42 HONEYSUCKLE DRIVE COTTAGE CREEK PRECINCT NEWCASTLE

NEWCASTLE CITY COUNCIL
DEVELOPMENT APPLICATION

ARCHITECTURAL DESIGN STATEMENT

SUMMARY OF PROPOSED AMENDMENTS

2.1 DESIGN CHANGES SECOND FLOOR

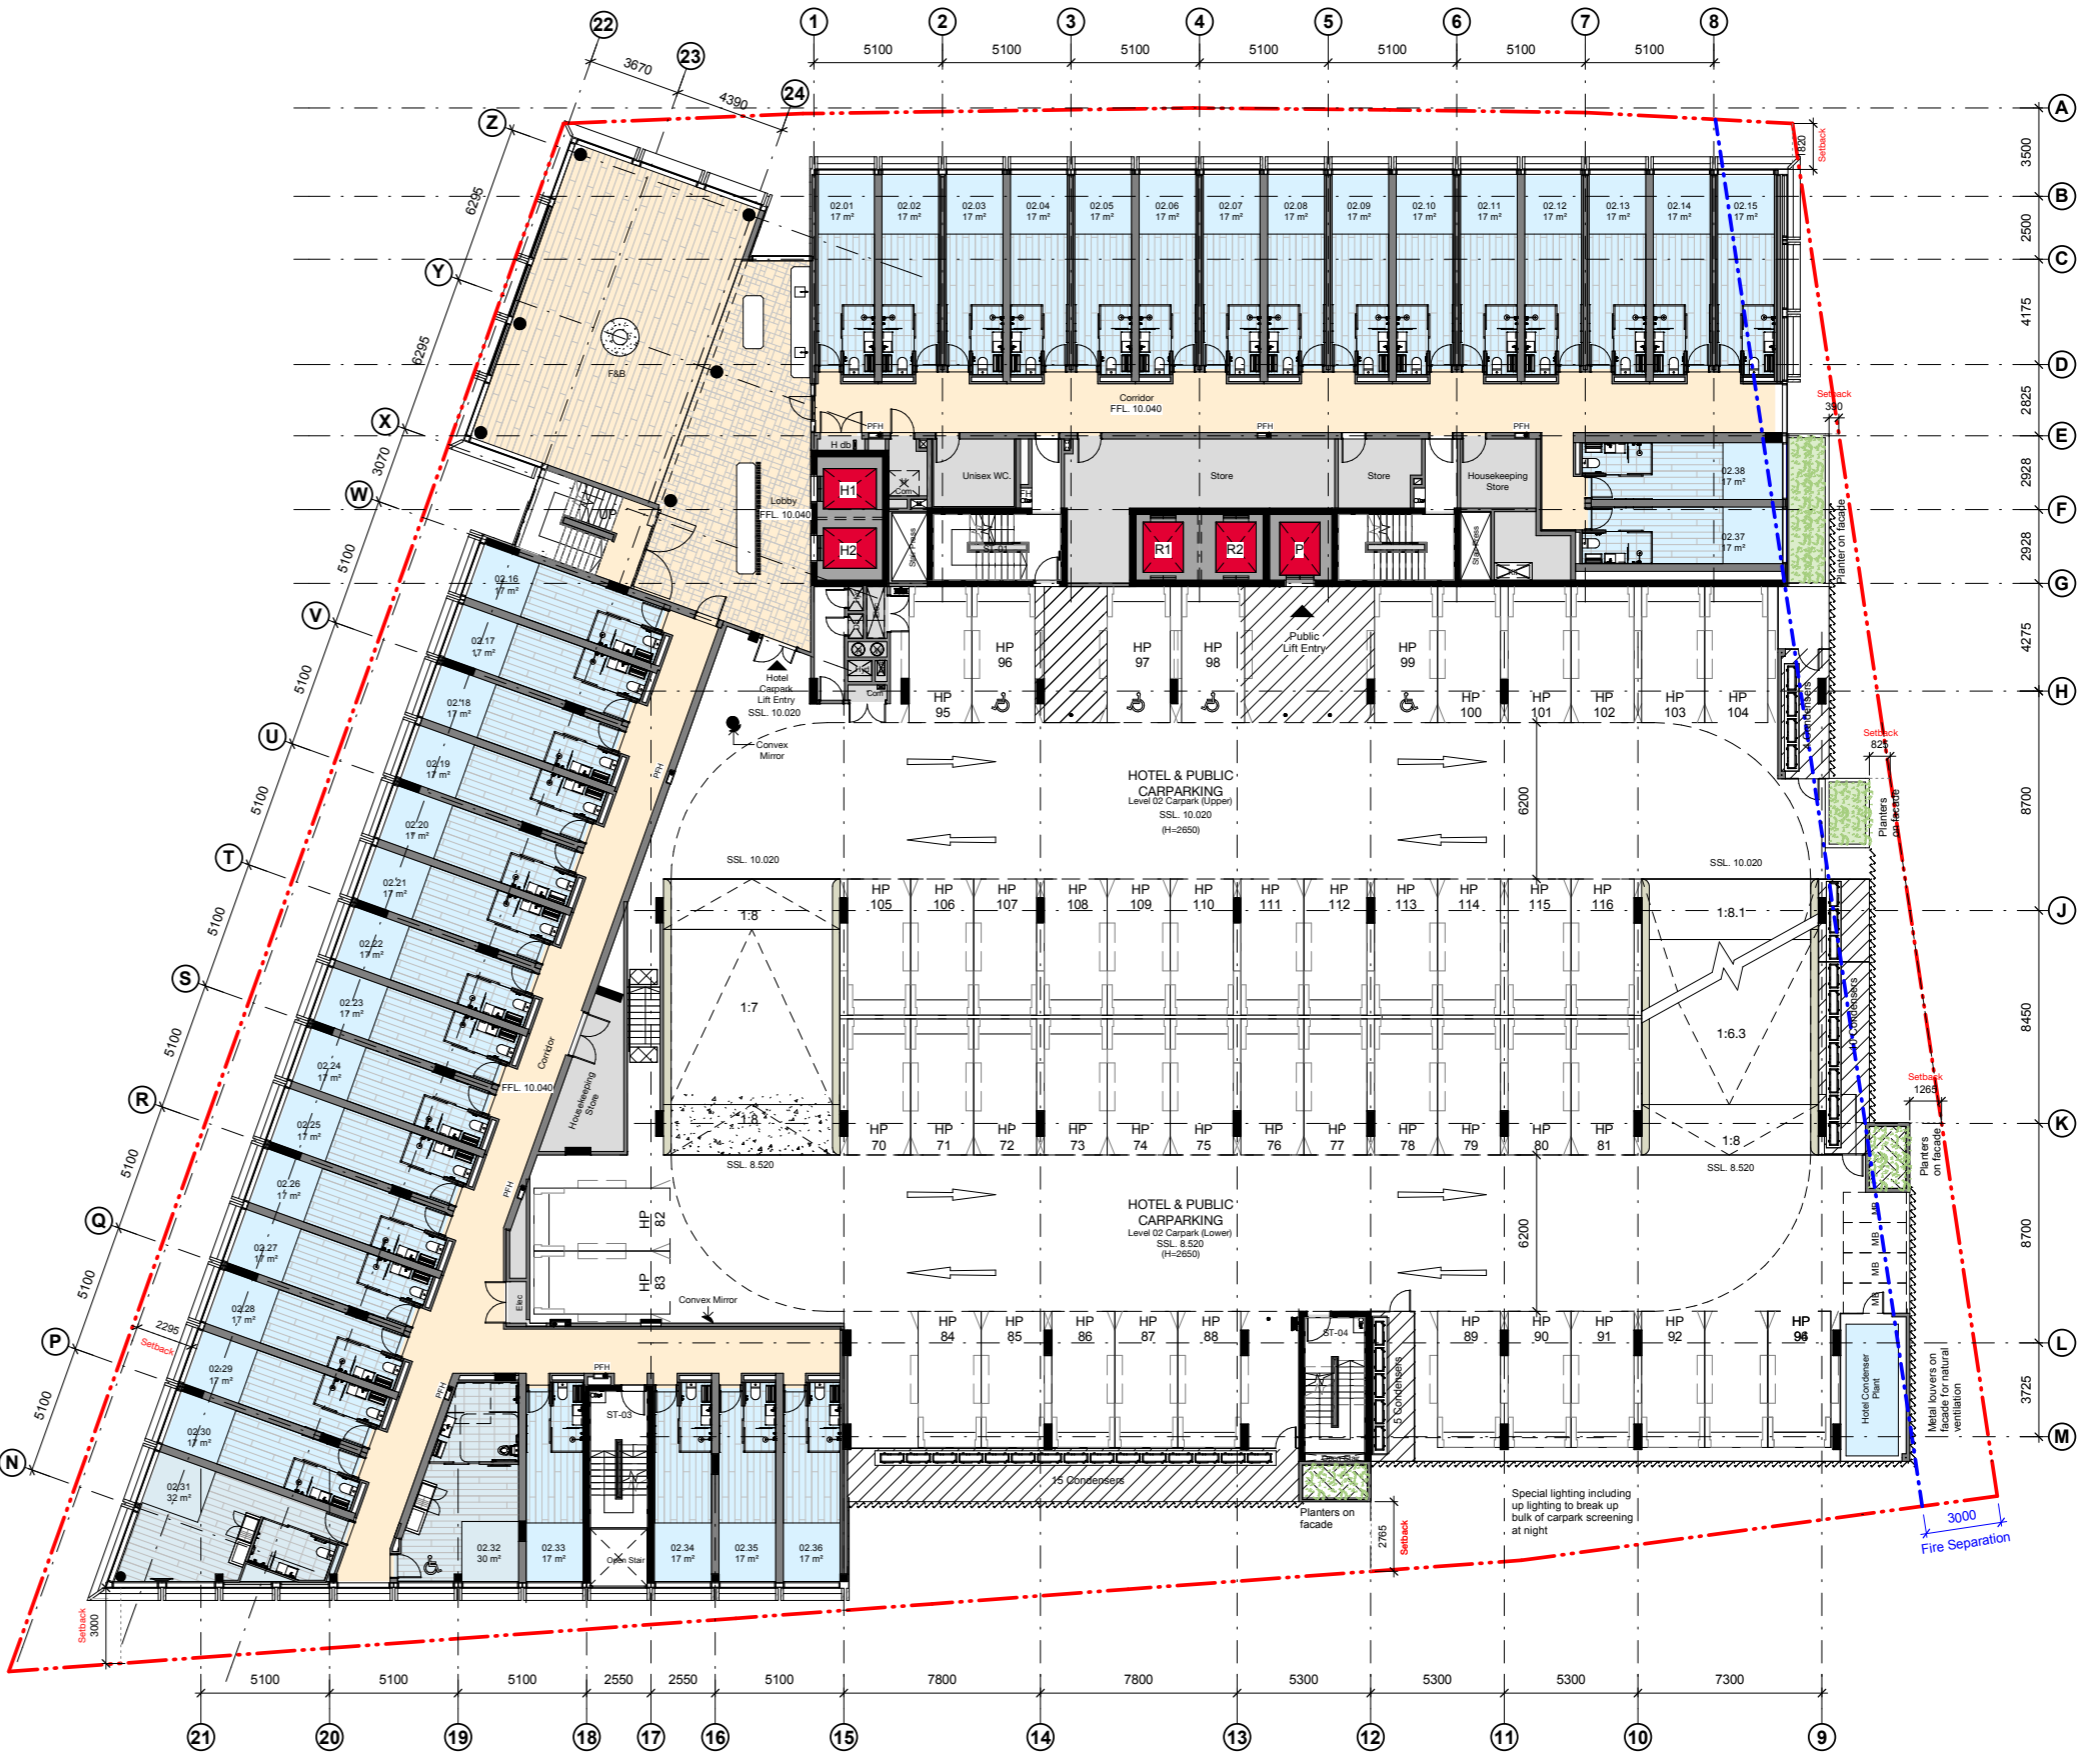
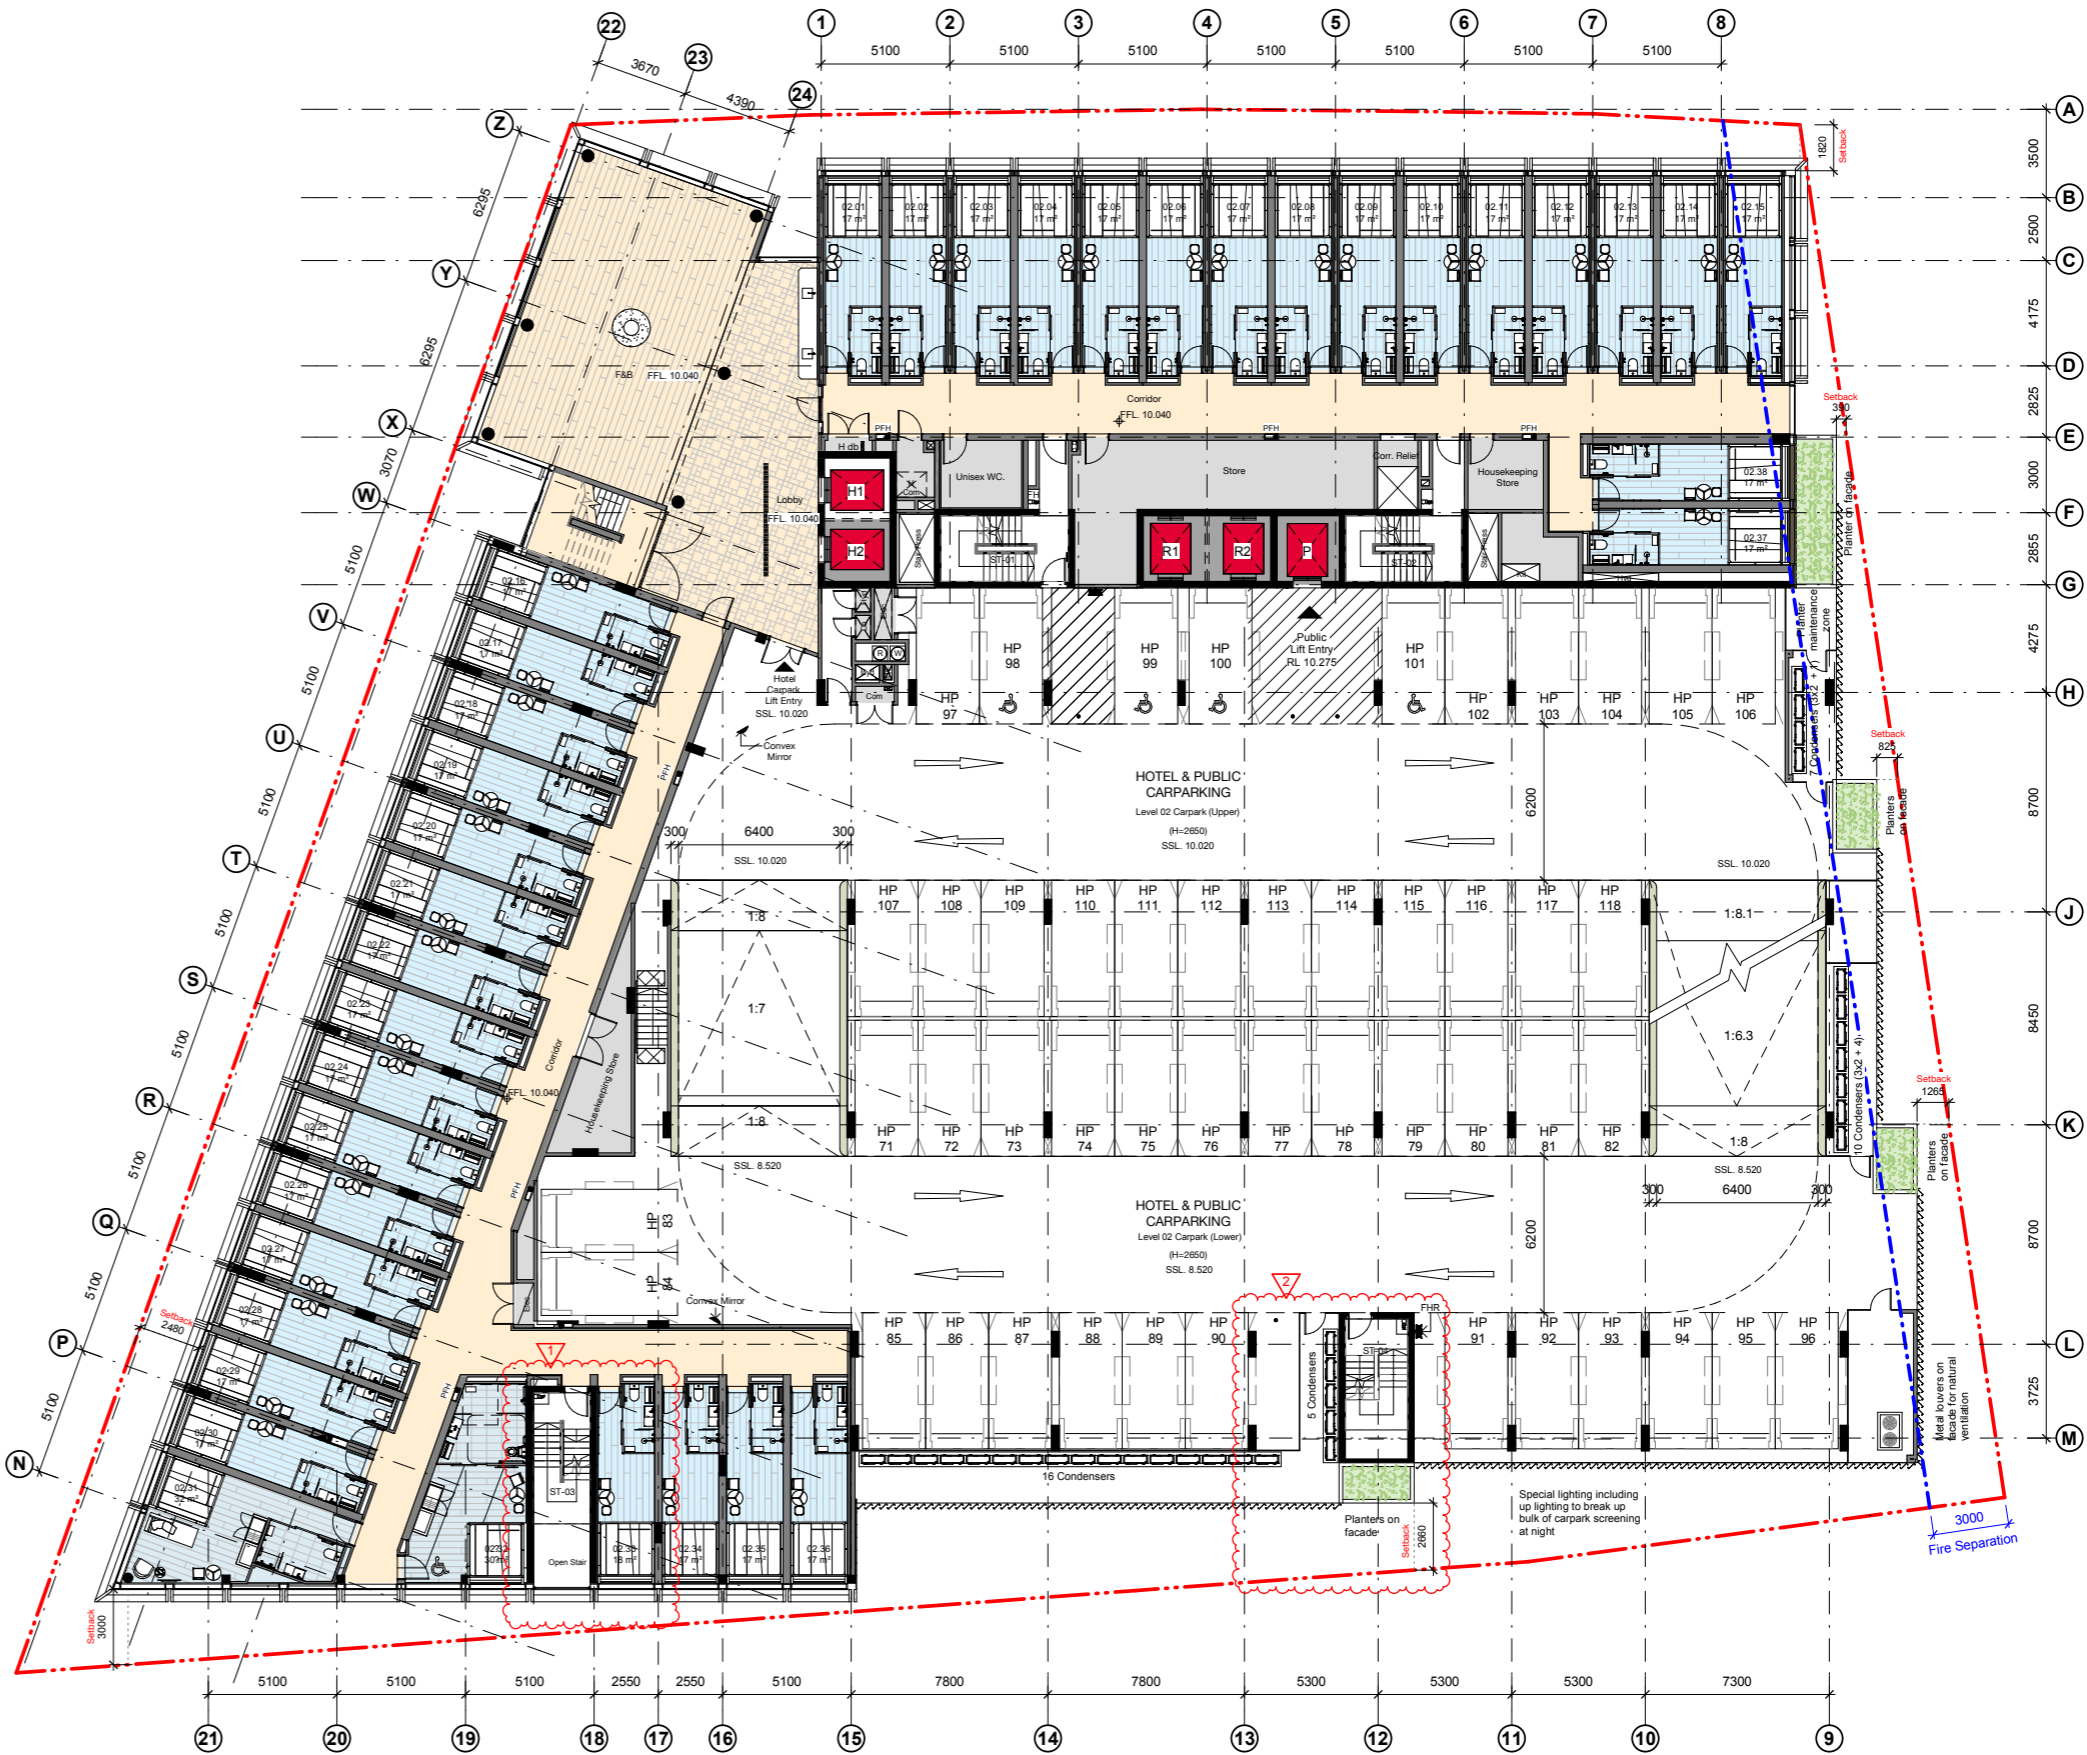
- 1 / Adjustments to the location of the south western fire stair. To accommodate the revised serviced apartment floorplate, the fire stair shifts to the west by one hotel bay. Facade treatment from Ground to Level 04 are adjusted to suit.
- 2 / Adjustments to the location of the south eastern fire stair. To accommodate the revised serviced apartment floorplate, the fire stair shifts to the east. Facade treatment from Ground to Level 05 Parking are adjusted to suit.

3.1 DESIGN CHANGES THIRD FLOOR

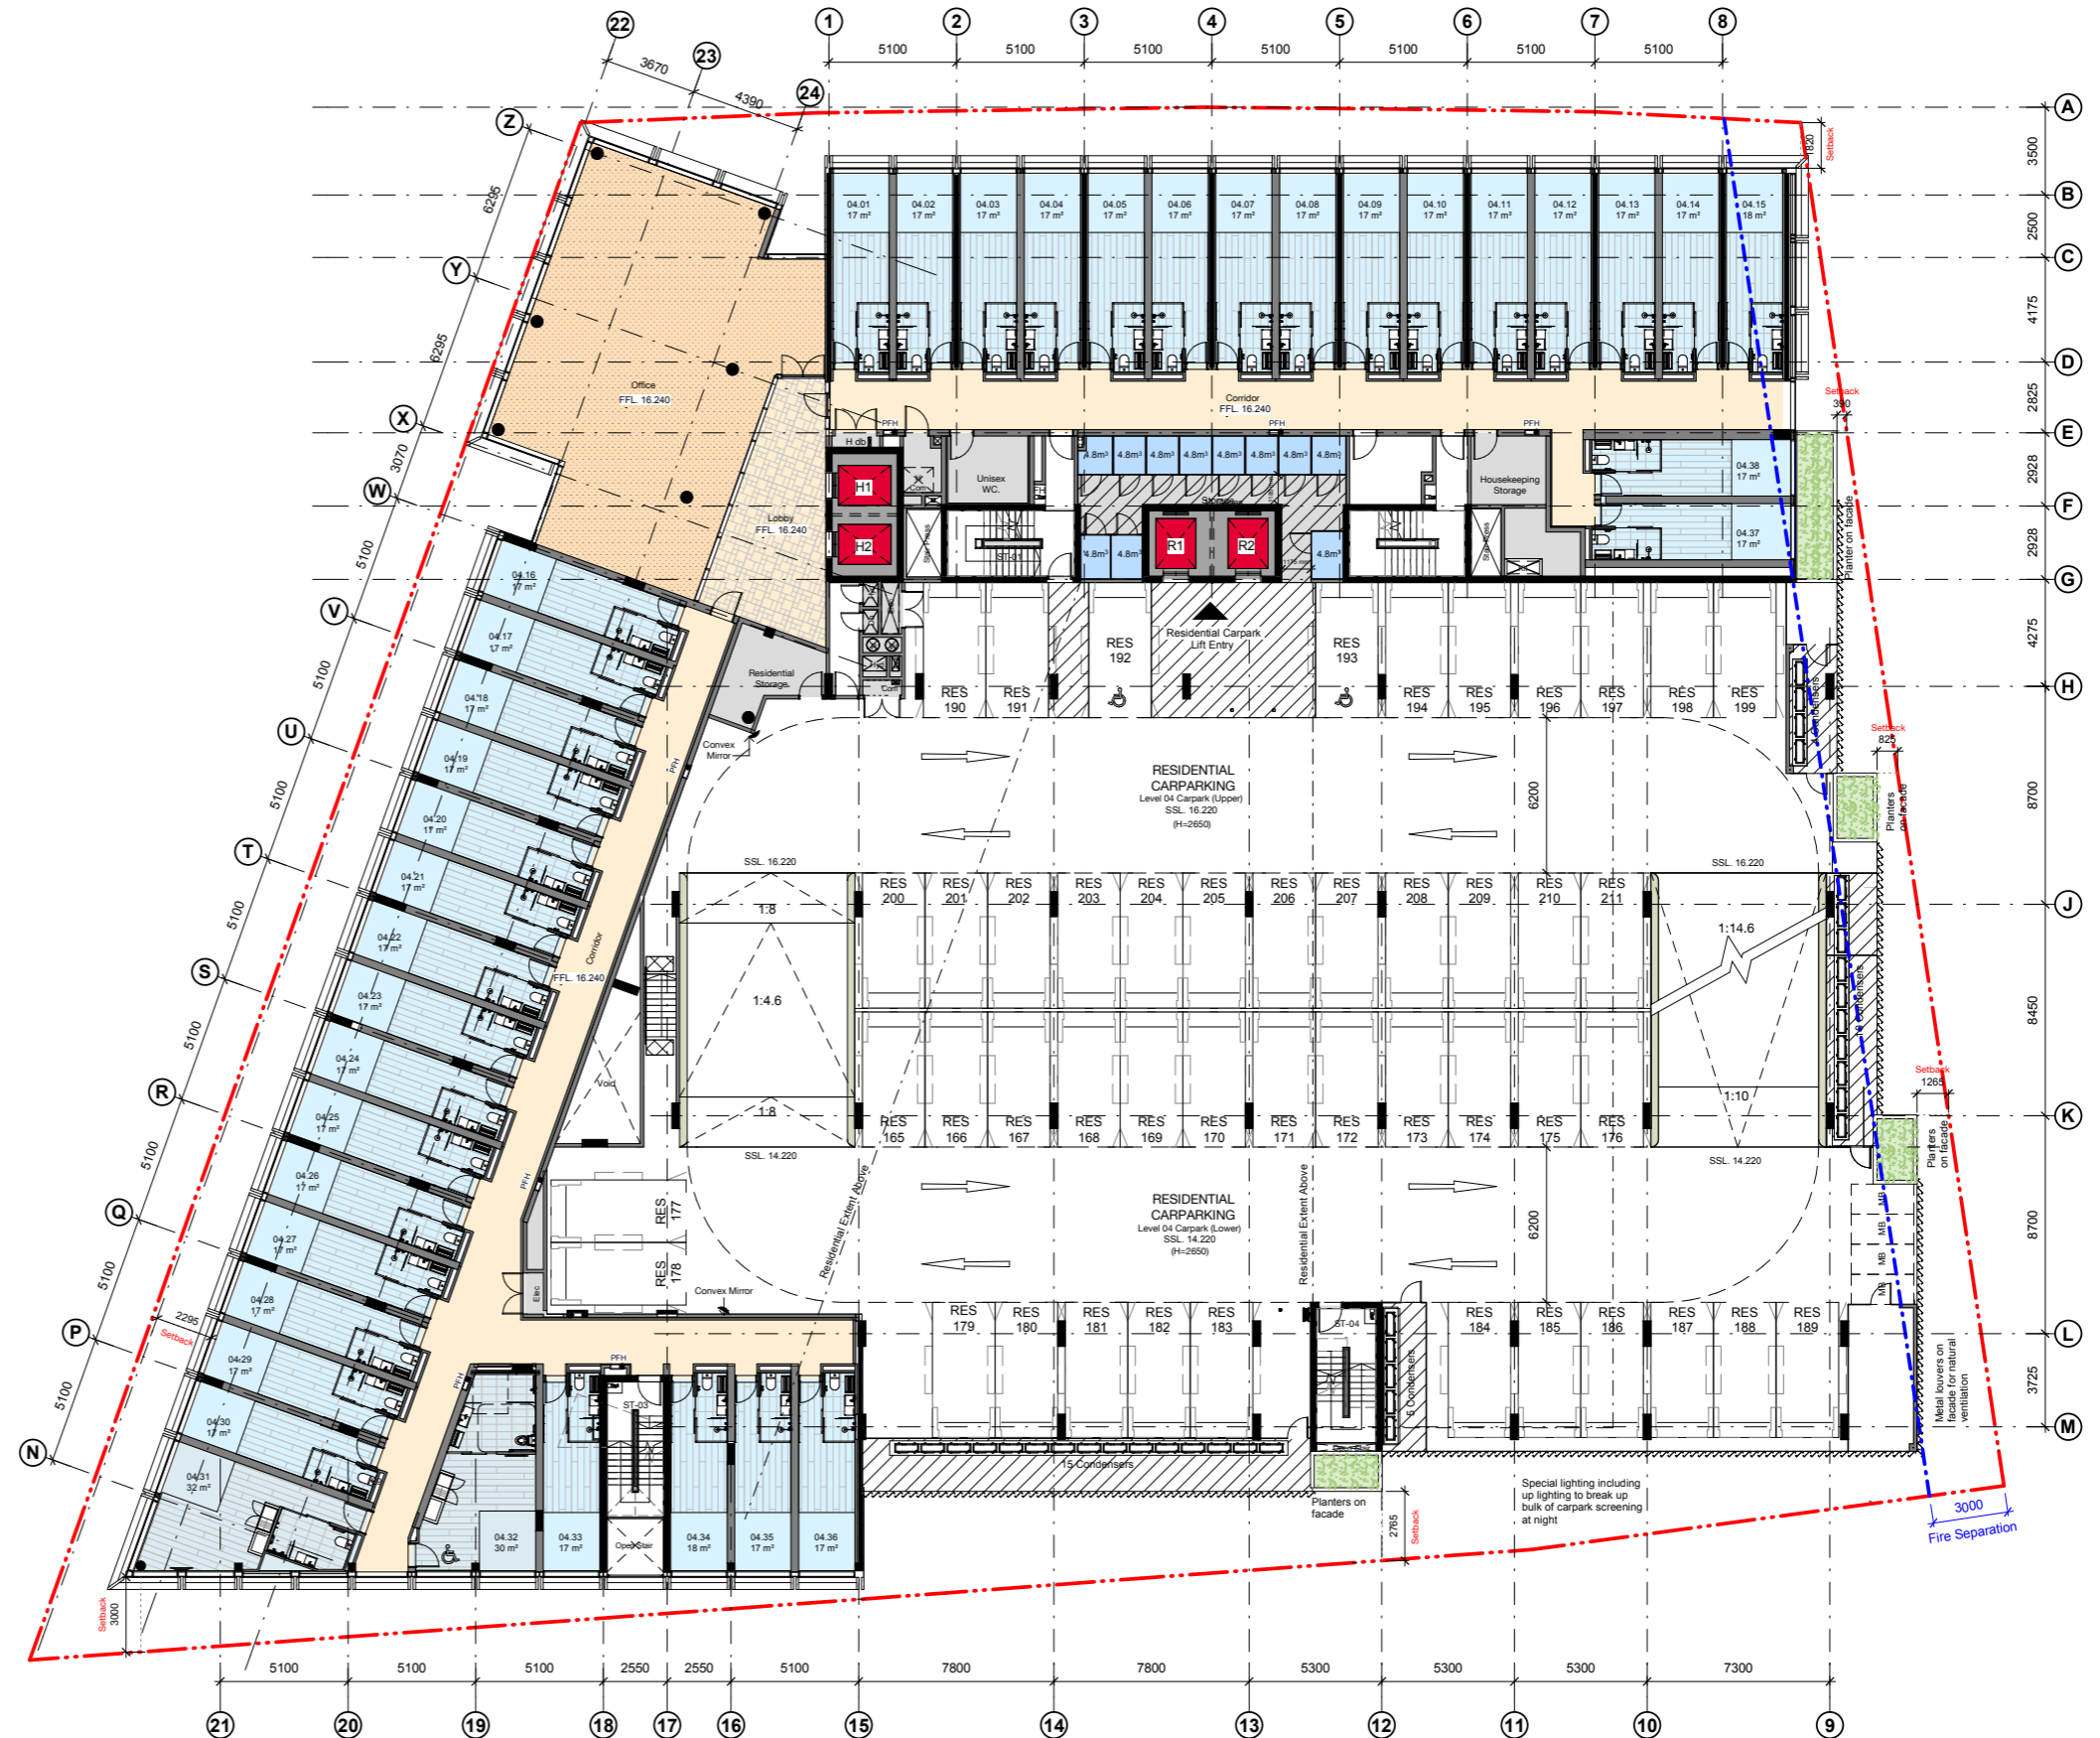
- 1 / Adjustments to the location of the south western fire stair. To accommodate the revised serviced apartment floorplate, the fire stair shifts to the west by one hotel bay. Facade treatment from Ground to Level 04 are adjusted to suit.
- 2 / Adjustments to the location of the south eastern fire stair. To accommodate the revised serviced apartment floorplate, the fire stair shifts to the east. Facade treatment from Ground to Level 05 Parking are adjusted to suit.
